SERVICE **HARLEY-DAVIDSON** BULLETIN

No. 597

September 16, 1969

IMPORTANT TIRE INFORMATION / 1970 SPORTSTER

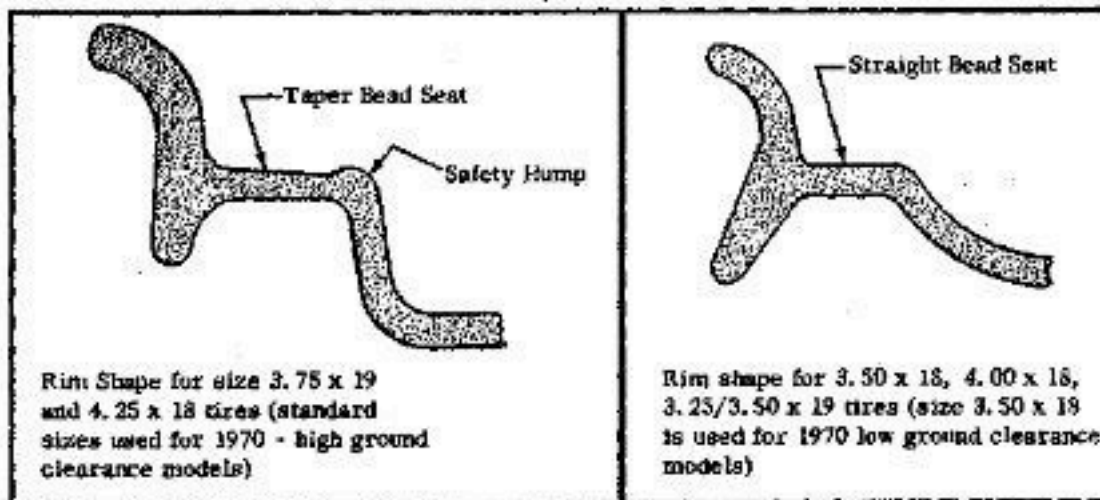
These tires must be used exclusively for replacement on these rims. This type rim has a special tapered bead seat with a safety hump as shown in sketch below. Standard tires such as Goodyear 3.50 x 18, 4.00 x 18 or 3.25/3.50 x 19 sizes will not fit correctly and will result in unsafe operation if installed for any reason.
